Access Compliance Report

Public Rights-of-Way

Intersection ID: 27962	Main Street: PINE_VALLEY_CLUB_DR	Cross Street: ROYAL_ABERDEEN_CT	Location: NE
ADA ID: 094CCB35125D	Ramp Type: Perp	Initial Pass/Fail: Fail	Overall Compliance: No
Codes/Mitigation Info/Possible Solution		Field Measurements/Component Compliance	
Severity Score: 13.75

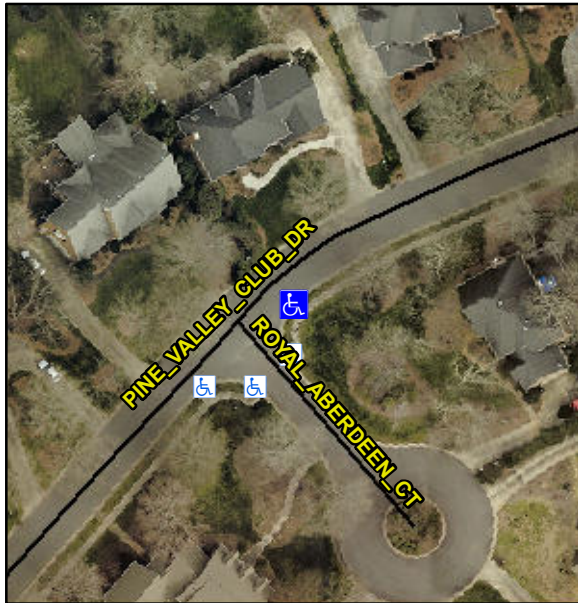
Not Found, R304.2.2, R304.5.3

Compliance	Description	Data	Compliance	Description	Data
N/A	Ramp Length (in)	49.0	No	Ramp Slope (%)	10.6
Yes	Ramp Width (in)	48.0	No	Ramp XSlope (%)	2.2
N/A	Flare Type LT	N/A	N/A	Flare Type RT	N/A
N/A	Flare Slope LT (%)	N/A	N/A	Flare Slope RT (%)	N/A
N/A	Flare Traversable LT?	N/A	N/A	Flare Traversable RT?	N/A
N/A	Landing Length (in)	N/A	N/A	DWS Provided?	N/A
N/A	Landing Width (in)	N/A	N/A	DWS Contrast?	N/A
N/A	Landing Slope (%)	N/A	N/A	DWS Length (in)	N/A
N/A	Landing X Slope (%)	N/A	N/A	DWS Full Width?	N/A
N/A	Landing Curb? (Y/N)	N/A	N/A	DWS Offset (in)	N/A
N/A	Shared Landing?	N/A			
N/A	Gutter Ponding?	N/A	N/A	Gutter Slope (%)	N/A
N/A	Gutter Lip Ht (in)	N/A	N/A	Gutter X Slope (%)	N/A
N/A	Painted X Walk1?	No	N/A	Painted X Walk2?	N/A
	X Walk 1 Direction	To NW		X Walk 2 Direction	N/A
N/A	X Walk 1 Width (in)	N/A	N/A	X Walk 2 Width (in)	N/A
	X Walk 1 Slope (%)	3.5		X Walk 2 Slope (%)	N/A
	X Walk 1 X Slope (%)	1.5		X Walk 2 X Slope (%)	N/A

Remove & Replace Entire Ramp.
